**Town Planning compliance advice re: extension of
existing medical centre and new signage**
Against the *Kingborough Interim Planning Scheme 2015*

**20 Channel Highway, Kingston TAS 7050
(CT-154504/1)**

RFI RE: PROPOSED DEVELOPMENT/USE – EXTENSION TO MEDICAL CENTRE (GENERAL PRACTICE) AT 'KINGSTON PLAZA', 20 CHANNEL HIGHWAY, KINGSTON

7 Version 3 signage plans

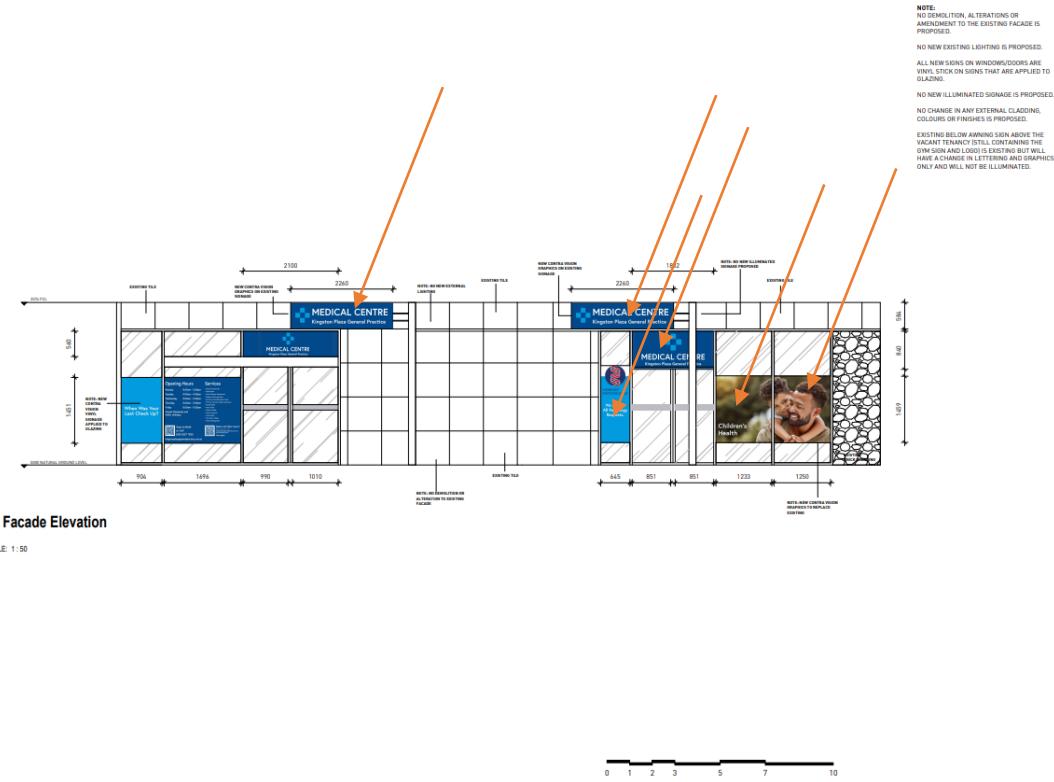
6. Information provided is not adequate. It is acknowledged that a Planning Report prepared by Gray Planning has been submitted which provides an assessment against Clauses 22.4.3 and 22.4.4. However, the report does not acknowledge or address that the building façade and external wall are being altered through the inclusion of solid window signage. This alteration requires explicit consideration under both Clauses, as the signage has the potential to reduce transparency to the street, diminish activation of the façade, and limit opportunities for passive surveillance. Accordingly, you are requested to provide an amended planning report or separate assessment against Clause 22.4.3 – Design and Clause 22.4.4 – Passive Surveillance, having regard to the changes to the building façade arising from the proposed window signage.

The plans have been amended to the following version showing a reduction in signage originally proposed:

Existing signs subject to a change in graphics, colour or logo in the above elevation drawing that have been indicated with an arrow.

1 | Facade Existing Elevation

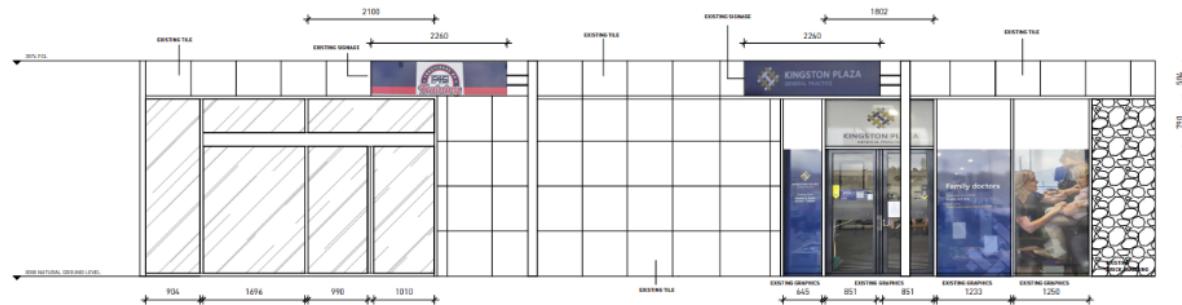
In terms of existing signage that is proposed to have a change in letter or graphics, the following indicates what existing signs at the subject site are proposed to have a change of colour, lettering or graphics:

- 2.2 wide x 0.58 high sign in existing Below Awning signs comprising dark blue background with white lettering comprising medical centre name and logo, to replace existing gym logo and business name (no increase in sign size); and
- 0.64 wide x 1.45m high vinyl sign applied to existing window comprising mid blue background with white lettering '*New Patients and Families Welcome*' to replace existing centre name and logo on darker blue background (no increase in sign size); and
- Two x 1.23m wide x 1.45m high vinyl sign applied to existing window comprising a photo image of a man and a child to replace existing photo image (no increase in sign size).

In terms of the Below Awning Sign, the existing sign is understood to be previously approved for the former gym occupant and for this application, involves a change in graphics and lettering only and is therefore an Exempt sign under clause E17.4.3 of the E17.0 Signs Code.

1 | Facade Elevation

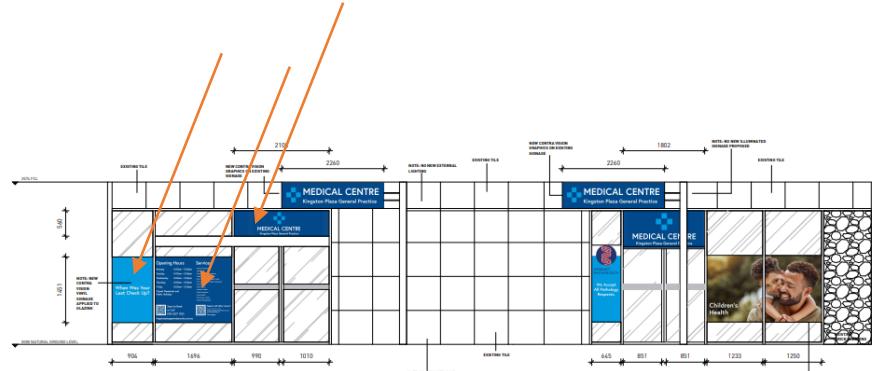
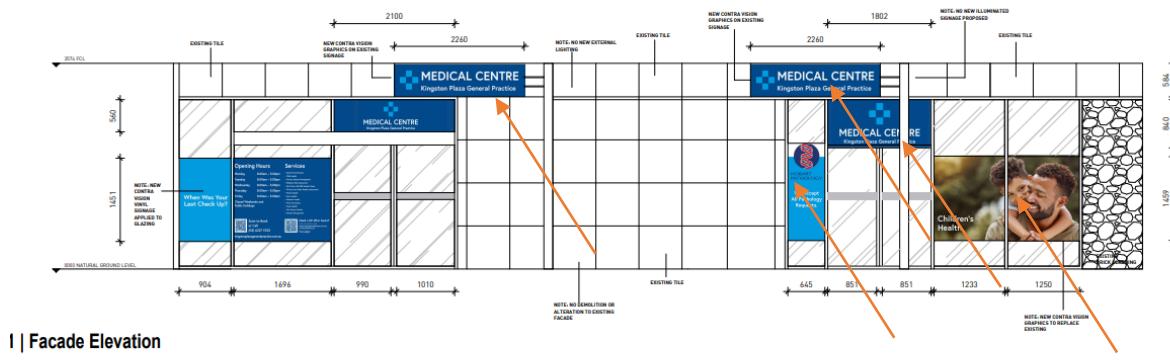
In terms of entirely new signage (not existing), the following **new** signs are proposed (arrowed) in amended Version 3 plans:

The three new signs being proposed at the empty tenancy formerly occupied by the gym are:

It is considered that they are integrated into the facades onto which they are to be placed and informative as they provide information to customers and passers by. They will not dominate the building onto which they are placed or the streetscape in terms of the percentage of overall façade they will cover across the available façade area.
